**MONTGOMERY COUNTY HISTORIC PRESERVATION COMMISSION**  
**STAFF REPORT**

<b>Address:</b>	111 Elm Ave., Takoma Park	<b>Meeting Date:</b>	2/12/2019
<b>Resource:</b>	Contributing Resource <b>Takoma Park Historic District</b>	<b>Report Date:</b>	2/6/2019
<b>Review:</b>	HAWP	<b>Public Notice:</b>	1/30/2019
<b>Case Number:</b>	37/03-18FFF (REVISION)	<b>Tax Credit:</b>	None
<b>Applicant:</b>	Sarah Boehm & Leonard Newmark	<b>Staff:</b>	Dan Bruechert
<b>Proposal:</b>	Window Replacement

BOEHM-NEWMARK RESIDENCE

111 Elm Avenue  
Takoma Park, MD 20912  
Interior Renovation

Figure 3: Left elevation showing the location of the proposed window replacement.

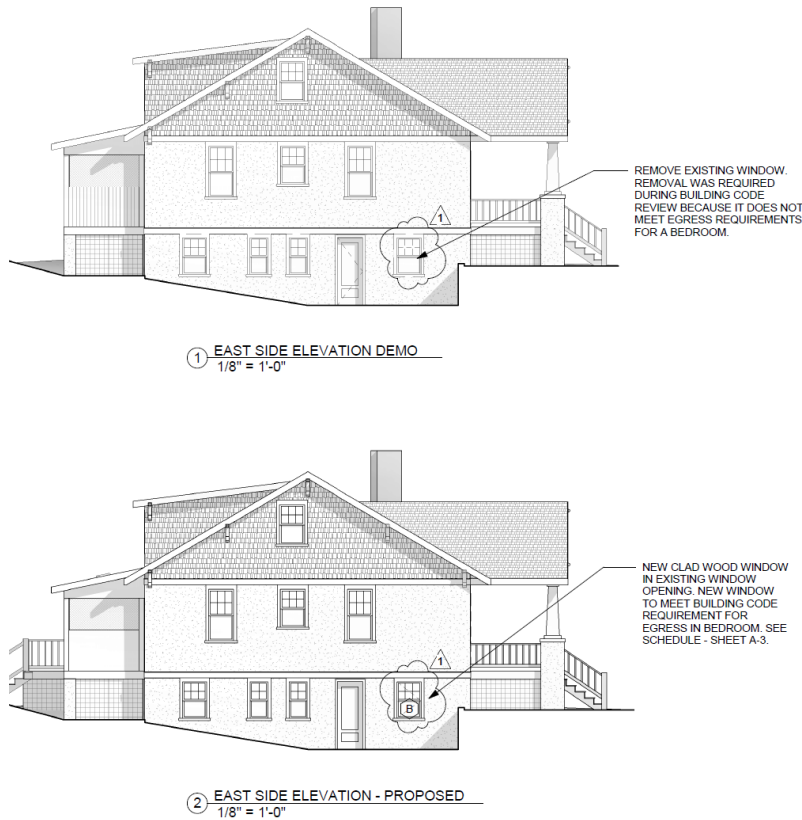
Current building code requires a 5 ft<sup>2</sup> (five square feet) opening for ground level egress. The existing window does not meet that requirement, as the opening for the sash window is approximately 4.666 ft<sup>2</sup> (four and two-thirds square feet). The applicant proposes to remove the existing six-over-one vinyl sash window and replace it with a wood-clad casement window that simulates the historic window pattern. The window will have permanently fixed interior and exterior grills and the an applied, thicker, meeting rail (the 2" horizontal member in the middle of the window).

Staff finds that this solution is appropriate for several reasons. First, the applicant is taking the steps to preserve the existing window opening. The new window will meet code only because its operation has been changed from a sash to a casement window. If the applicant wanted to preserve a sash window in this location, the opening would need to be enlarged, which would contravene the *Takoma Park Design Guidelines* regarding the retention of door and window openings. Second, as this is a basement window, it will have less impact on the character of the historic building than a first-floor window or a front-facing window would. Third, the applicant is preserving the appearance of the window by matching the lite pattern of the existing and will better maintain the character and appearance of the house. An enlarged sash window would introduce new proportions to the window and would be potentially visually incompatible. Staff recognizes that this window will be visible from the public right of way due to the change in grade along Elm Ave. and because of the relatively wide setback between 111 Elm and 113 Elm Ave; however, the proposed window is less visible and smaller than the more significant first floor windows.

Staff supports approval of this window finding that the dimensions and configuration are appropriate for the house, per Standard 2 and 24A-8(b)(2). The *Design Guidelines* state that non-original materials may be used on a case-by-case basis. Staff finds that this is an appropriate application of a non-original material because the single window is on a side elevation, at the basement level, and replaces a non-original, vinyl window with a more compatible window in terms of materials. This proposal will not replace or damage original building materials (per the *Design Guidelines*).

Staff Recommends the HPC approve the revision to HAWP 37/03-18FFF, finding the proposal is consistent with Chapter 24A-8(b)(2), Standard 9 and the *Takoma Park Design Guidelines* and with the general condition applicable to all Historic Area Work Permits that the applicant will present 3 permit sets of drawings to HPC staff for review and stamping prior to submission for permits.

① EAST SIDE ELEVATION DEMO  
1/8" = 1'-0"

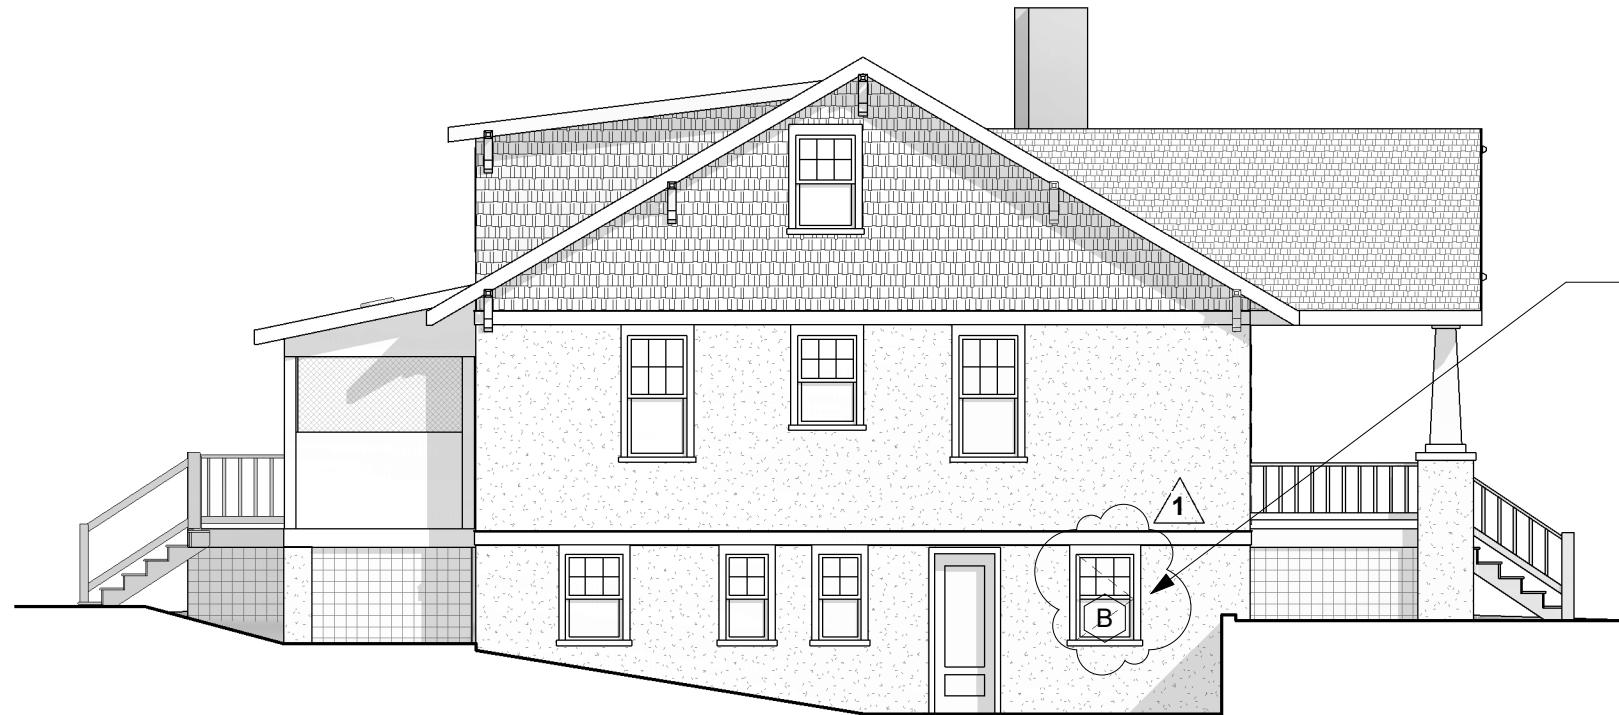
REMOVE EXISTING WINDOW.  
REMOVAL WAS REQUIRED  
DURING BUILDING CODE  
REVIEW BECAUSE IT DOES NOT  
MEET EGRESS REQUIREMENTS  
FOR A BEDROOM.

NEW CLAD WOOD WINDOW  
IN EXISTING WINDOW  
OPENING. NEW WINDOW  
TO MEET BUILDING CODE  
REQUIREMENT FOR  
EGRESS IN BEDROOM. SEE  
SCHEDULE - SHEET A-3.

Figure 1: April 2012 view of the house showing the right rear windows.

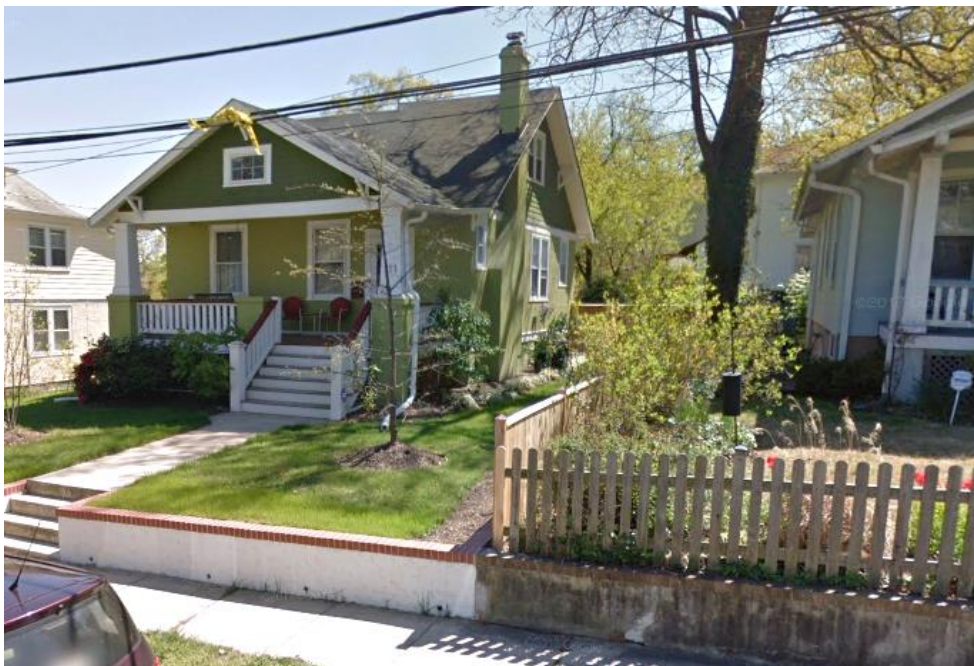
The revised proposal calls for moving the rear window on the right (west) elevation by 2' 6" (two feet, six inches) and installing a new clad window in its place. The applicant will patch the existing opening and paint the wall to match. The applicant proposes to install a JeldWen Sitaline six-over-one wood clad window in the same size as the existing window with permanently applied interior and exterior muntins. At the preliminary consultation the applicant indicated that the sash cords were broken, and the build-up of paint made the windows difficult to operate. Staff does not believe that this alone is sufficient to justify the removal of a historic wood window and that if this historic window was repairable it could provide decades of continued use (there are also Montgomery County Tax Incentives available for the repair of this element). While the proposed replacement window will be the same size as the existing, Staff remains finds that the proposal does not comply with the *Design Guidelines*, which states that consideration should be given to maintaining original window and door openings, where

feasible. The proposed work is on a secondary elevation; however, the *Guidelines* do not dictate a less rigid adherence except when work will not be at all visible from the public right-of-way. Staff finds that approval of this HAWP should be conditioned on retaining the window on the west elevation to comply with the *Design Guidelines*.

1. The window on the west elevation, needs to be maintained its historic location;
2. The new rear window needs to be wood. A clad window in this location is not appropriate. Submitted permit drawings must reflect compliance with this condition; and
3. Detailed specification for the skylights must be submitted for review and approval to Staff with the permit drawings with final approval authority delegated to Staff;
